Stage 1 SSD Development Application - One Sydney

SSD 15_7101 - D/2015/1049
Response to Submissions and Council RFI

November 2015

FIGURE 1 – PROPOSED TOWER SEPARATION WITHIN THE APDG PRECINCT (SOURCE: CRONE PARTNERS)

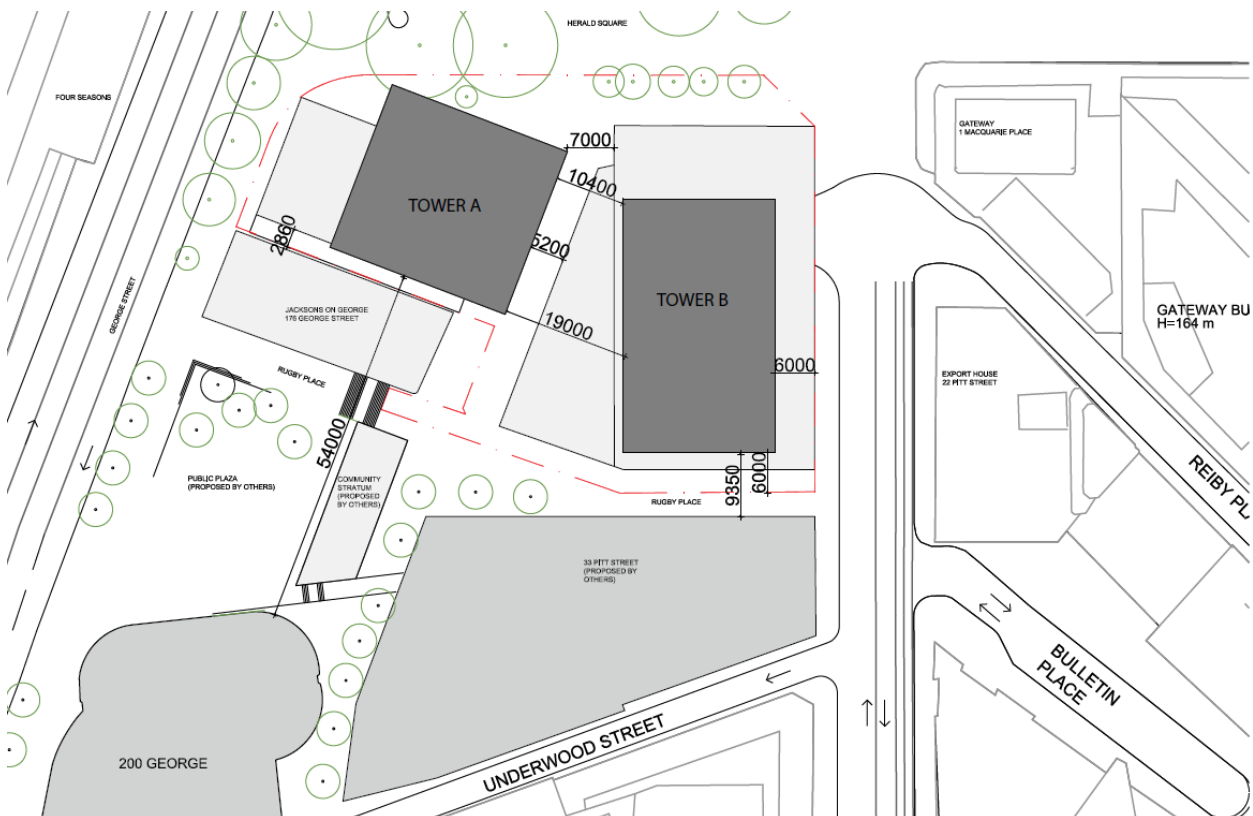
As a result of the submissions received, the proposal has been revised to increase the minimum tower separation between Tower A and Tower B from 6.92m to 10.4m. It is reiterated that this is the minimum building separation at the 'pinch point' between these buildings. The average tower separation will be 14.7m.

- The proposal results in appropriate view sharing as outlined within Section 3.3.
- The proposal complies with the required setback to Rugby Place and as such the separation between Tower B and properties to the south will be determined by the future development application for that land. This tower separation, based on the current LLCQ Tower Planning Proposal is illustrated in the following figure.

FIGURE 2 – VIEW OF THE PROPOSAL FROM NORTH (SOURCE: CRONE PARTNERS)

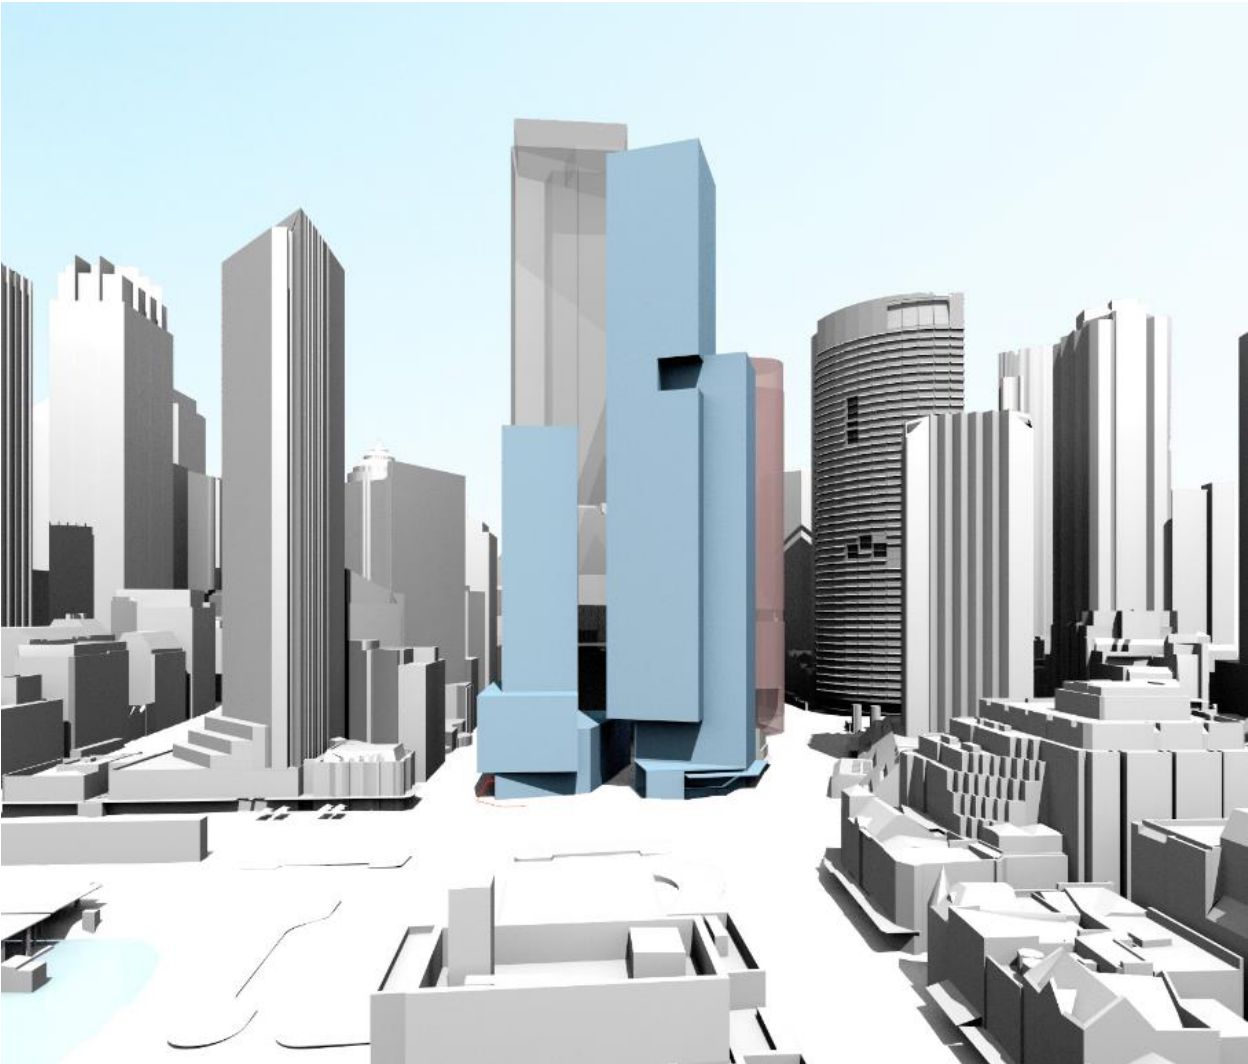
As illustrated within the following image, the revised separation between Tower A and Tower B reduces any perception of ‘crowding’ as viewed from Circular Quay compared to that lodged. Tower B however forms part of the prevailing building height control of the CBD and as such, when viewed from Circular Quay it will be read as part of the overall height datum, rather than a projecting tower form.

FIGURE 3 – EXTENT OF VIEWS STILL ACHIEVED DESPITE PROPOSAL (SOURCE: CRONE PARTNERS)

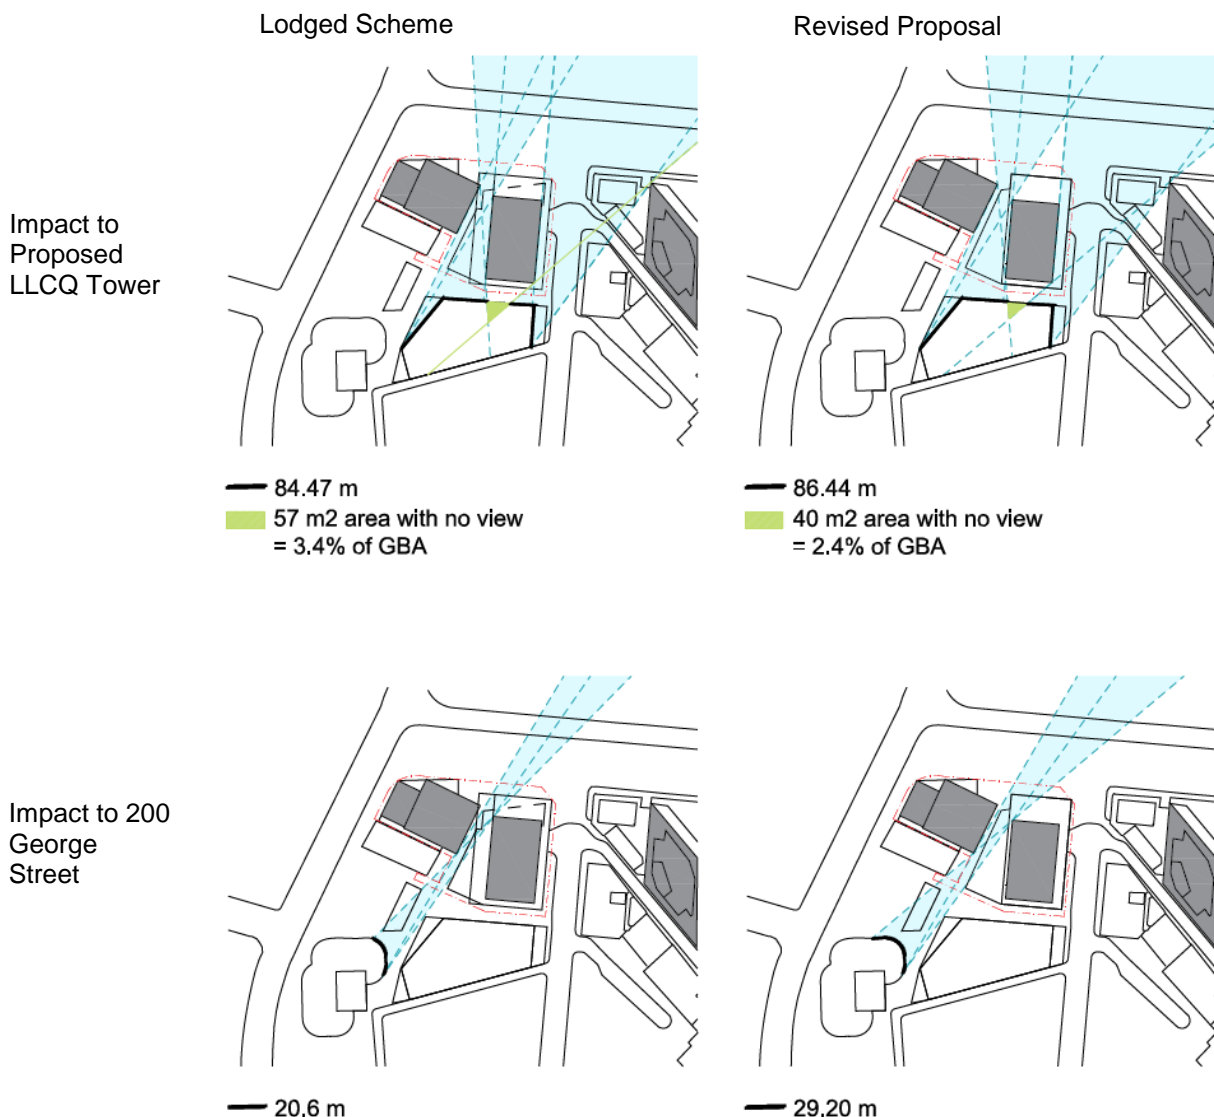
The submissions received on behalf of 200 George Street and the LLCQ Tower submits that appropriate view sharing has not been achieved within the precinct. The amount of ‘views’ lost by these two private commercial buildings is minor comparative to their overall floor plates, building height, and opportunities for further views towards the Harbour Bridge (in the case of 200 George Street). The submissions also refer to appropriate view sharing when compared to what they may have achieved based on the approved schemes within D/2015/2029 and D/2010/1533 (as distinct from views that currently exist).

The following image illustrates the extent of the typical floor plates of each of these buildings below RL112 that will still achieve views to Sydney Harbour, orientated towards iconic elements. As such, despite the nature of the views being ‘iconic’, appropriate view sharing is still achieved across the precinct particularly compared to the existing Goldfields House development.

FIGURE 5 – LEND LEASE SUGGESTED AMENDMENTS FOR THE SITE (SOURCE: HASSELL)

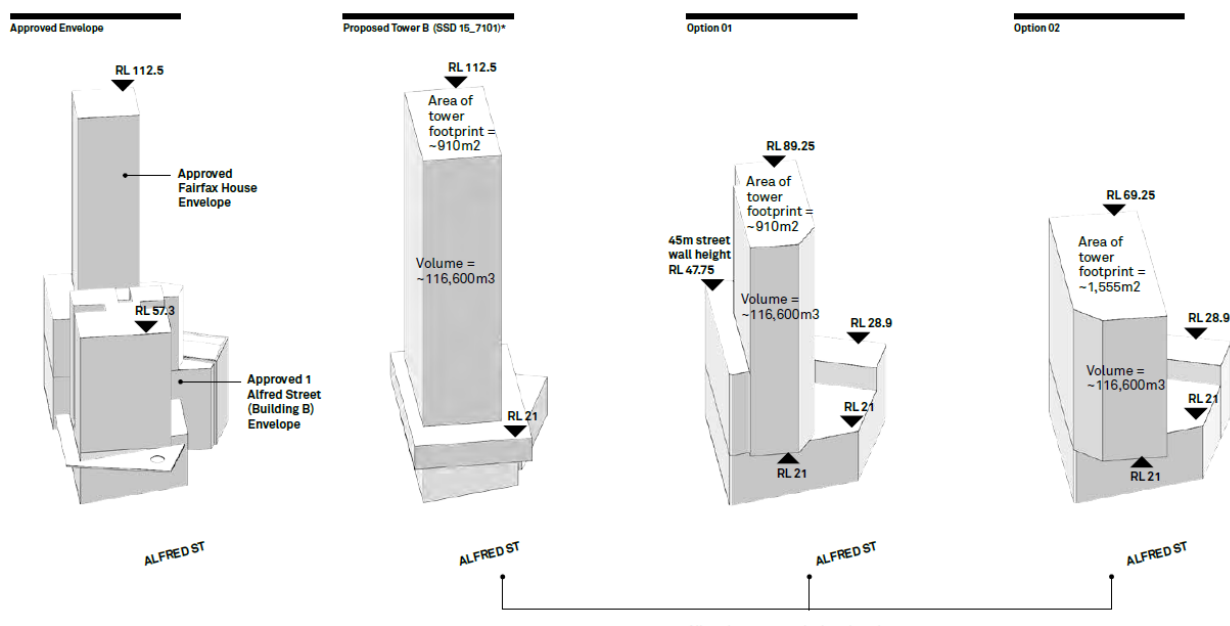
The submission prepared by BBC on behalf of Lend Lease was accompanied by a detailed report prepared by Hassell which made six suggestions for alternative approaches to the Tower B envelope which resulted in two massing options for the site, as shown below.

1. **Alfred Street Edge** – Tower B will not be relocated further to the north as it would result in a significant overhang of the podium at Alfred Street or alternatively reduced public domain dedication, reduced views to the proposed residential units approved at Tower A (a more sensitive land use) and a reduced view corridor to 200 George Street. This would also increase overshadowing to the proposed through-site link and public domain.
2. **Pitt Street Edge** – The revised proposal does include a 6m setback to Pitt Street and an increased street wall height (30m) compared to that proposed. A 45m street wall height is not proposed as it

3. **Western Alignment** – The Western Alignment is not pursued as it cannot accommodate the required hotel floor plate.
4. **Tower Separation** – The 900mm extension to the eastern façade of Tower A is not being pursued within the revised proposal. This GFA however is not being relocated to the northern façade of the building, and will be reallocated within the footprint of Tower A. The proposal is compliant with the SDCP 2012 setback control to Rugby Place and as such there is no requirement of the proposal to be further setback from the southern boundary. As a result of the concessions made by the proponent, the revised development achieves a minimum tower separation of 10.4m between Tower A and Tower B.

6. **View Sharing** – Improved view sharing is achieved across the APDG block as a result of the proposed amendments to the development. This is outlined within the revised View Impact Analysis (**Appendix D**) and Section 3.3 of this response to submissions report.

FIGURE 6 – AMENDED PROPOSED BUILDING ELEVATION (SOURCE: CRONE PARTNERS)

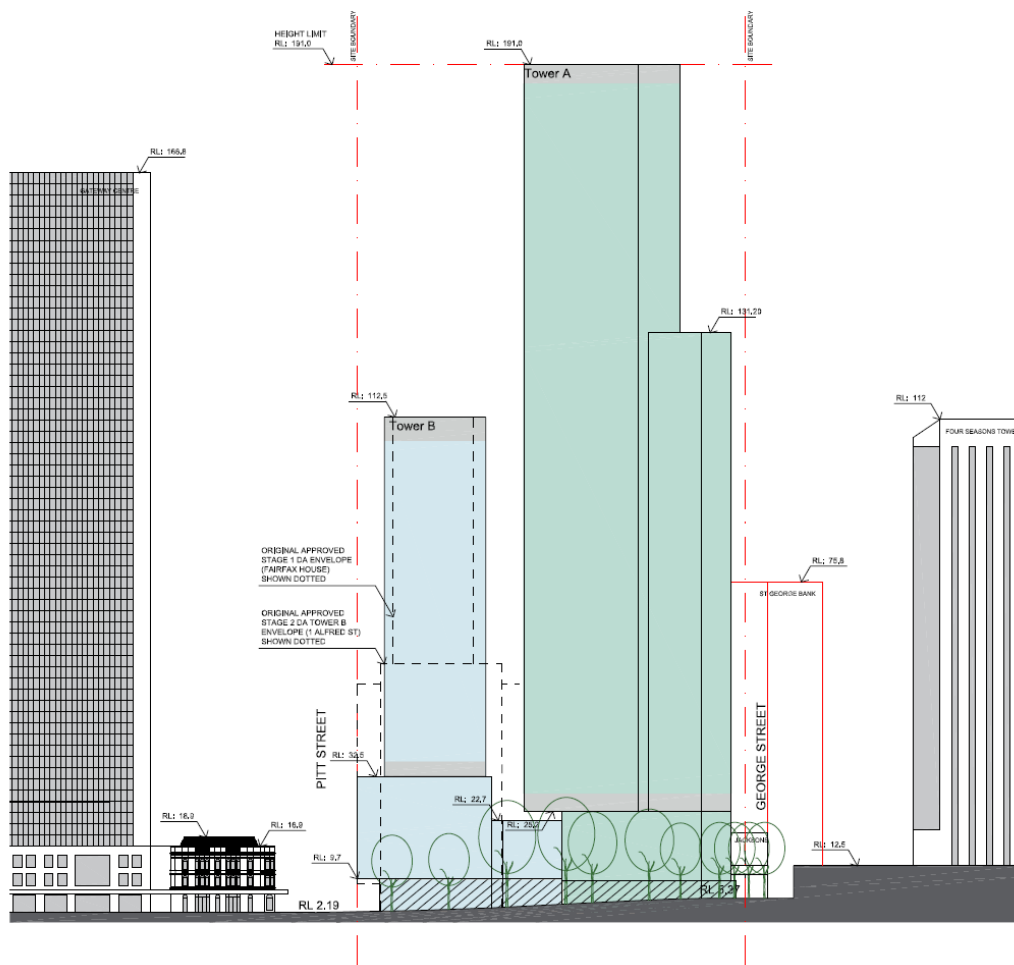
In response to the matters raised in the submissions, the City of Sydney's ongoing assessment of the application, and the on-going design process, the proponent has taken this opportunity to make some amendments to the building envelopes originally proposed and exhibited. The proposed amendments reduce the impact of the proposal on adjoining properties, whilst ensuring the objectives of the project are maintained.

The proposed building envelopes are illustrated in Figure 6 below.

FIGURE 7 – COMPARISON OF PROPOSED RELATIONSHIP BETWEEN TOWER A AND TOWER B AS LODGED AND AMENDED (SOURCE: CRONE PARTNERS)

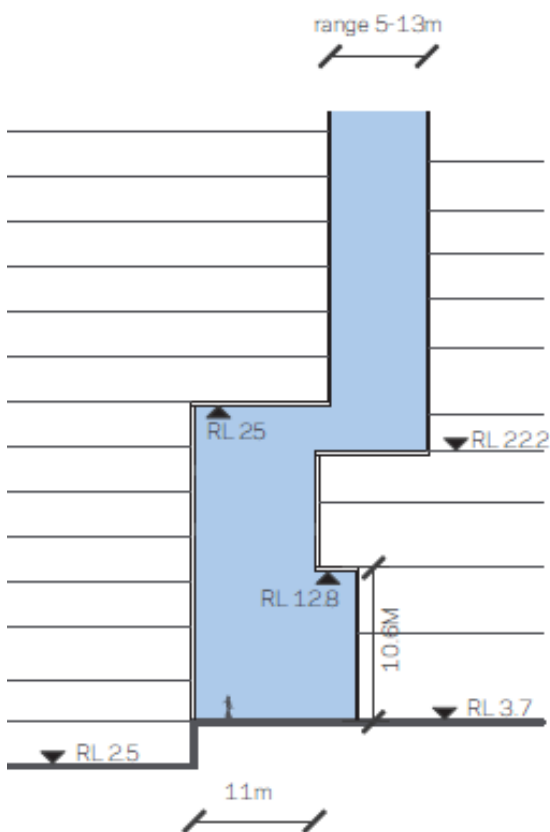
The revised proposal includes a minimum 10.4m building separation between the two towers on the site (excluding any façade fenestration such as louvres), which expands to 19m towards Rugby Place. The relationship between the two towers at the podium level has also been revised to reflect the comments received from the City of Sydney Council, the Design Advisory Panel and the Design Integrity Panel. The revised relationship between the two towers at the podium level is illustrated below.

PICTURE 2 – REVISED THROUGH-SITE LINK PROPOSED

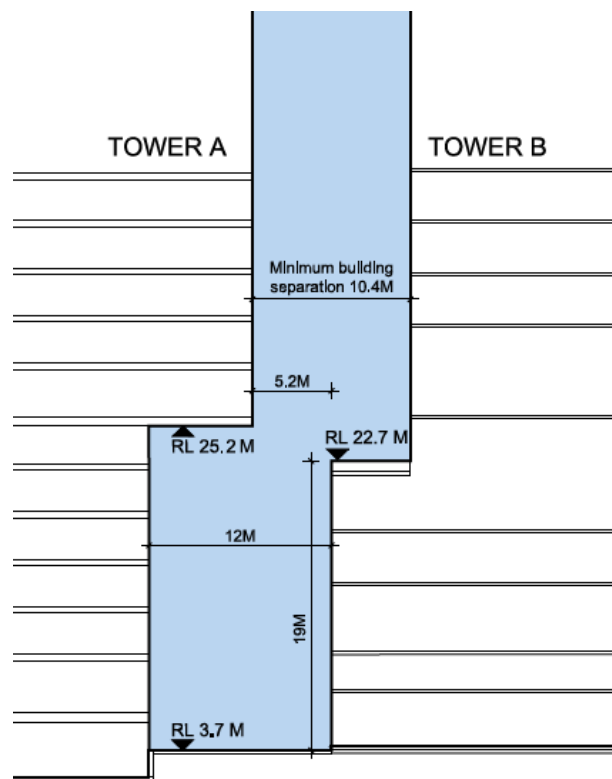
- Increase the height of the Pitt Street podium from 18.5m to 30m;
- Minor amendments to the proposed basement envelope;
- Revision to the proposed geometry of the through-site link reflecting revised floor to ceiling heights;
